Memorandum

To/Attention	John Sevigny City of Ottawa	Date	July 20, 2022
From	Lance Erion	Project No	103291.5.3.1
cc			
Subject	RSDC Phase 15-1A Redevelopment of Block 196 Solarium Avenue

To/Attention	John Sevigny, City of Ottawa	Date	May 11, 2022
From	Mahsa Ghasri Terry Brule	Project No	103291- 5.2.2.1
cc	Marcel Denomme, Urbandale		
Subject	Assessment of Revised Block 196 Storm and Sanitary Servicing

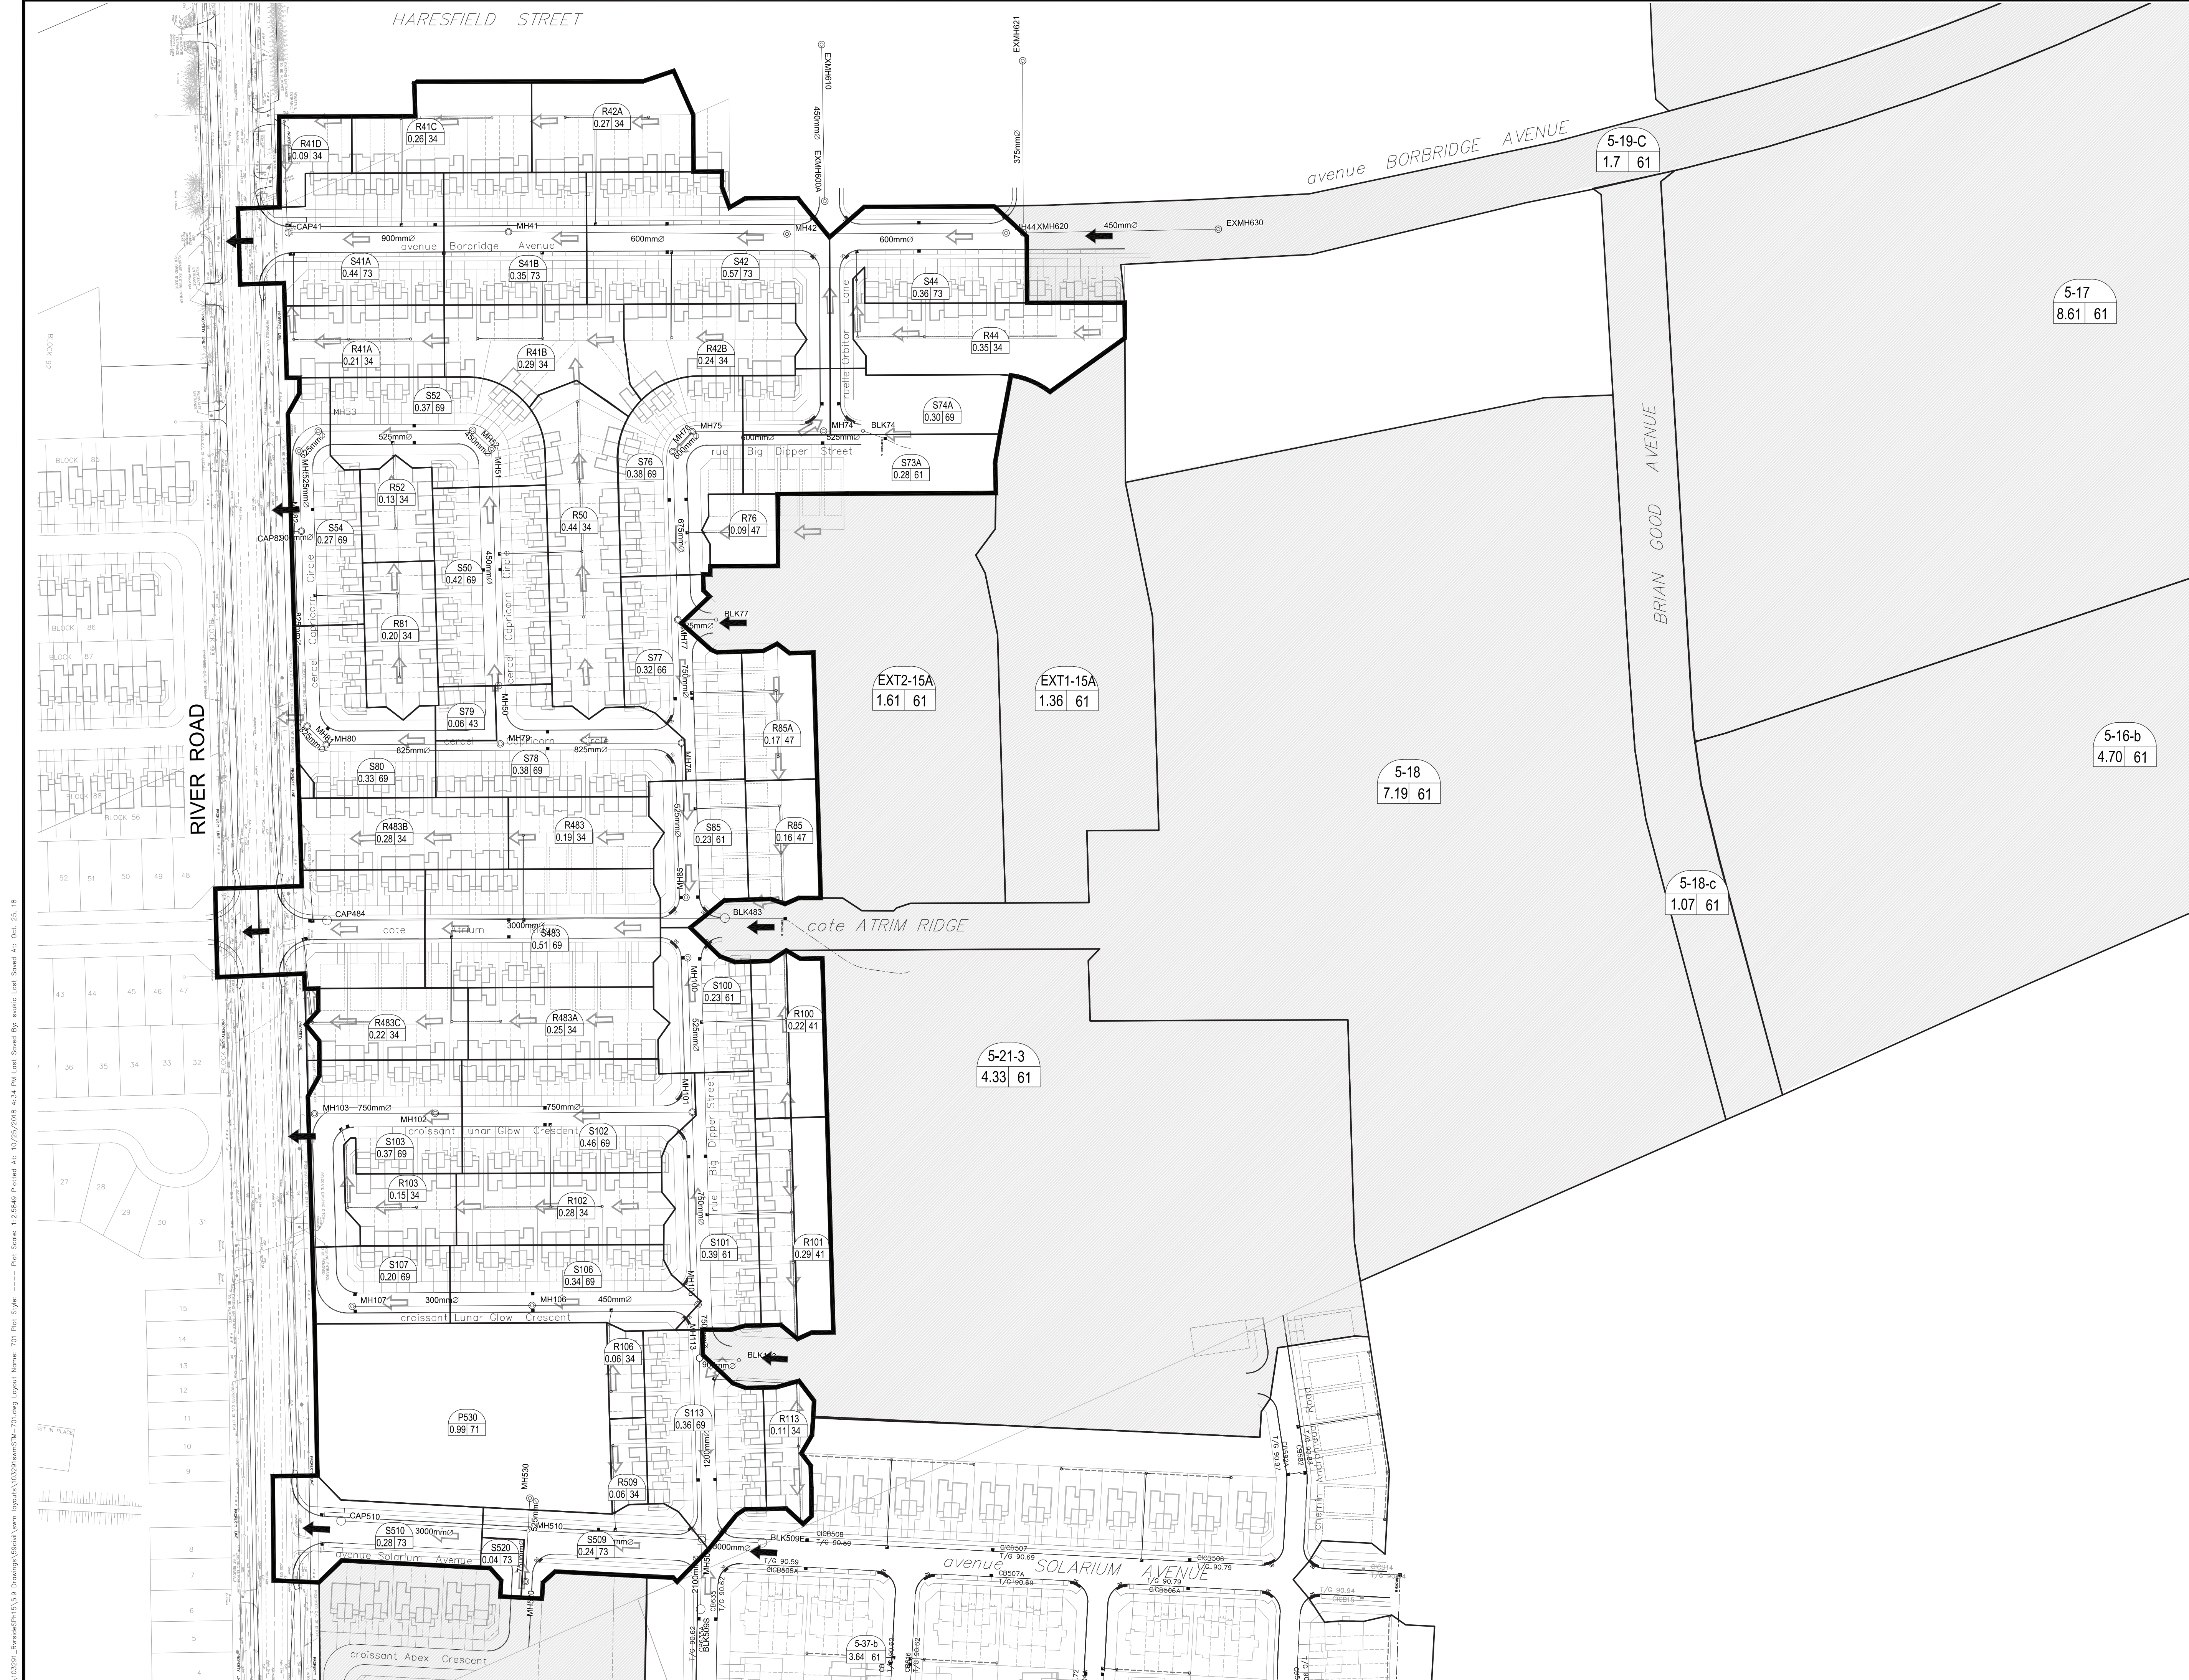
- 100 year 12 hour SCS Type II storm event consistent with the 2018 Pond 5 Design Brief.
- **Area and Imperviousness:** Block 196 (identified as drainage area P510) has been discretized into two drainage area, R510A and R510B. An imperviousness value of 34% has been applied.

- **Minor System Capture:** The minor system capture for the discretized drainage area is set to 2 year storm event and connected to MH 510 on Solarium Avenue.

- **Major System Storage and Routing:** The major flow from the discretized drainage area is routed to River Road side ditch. No on-site storage is proposed.
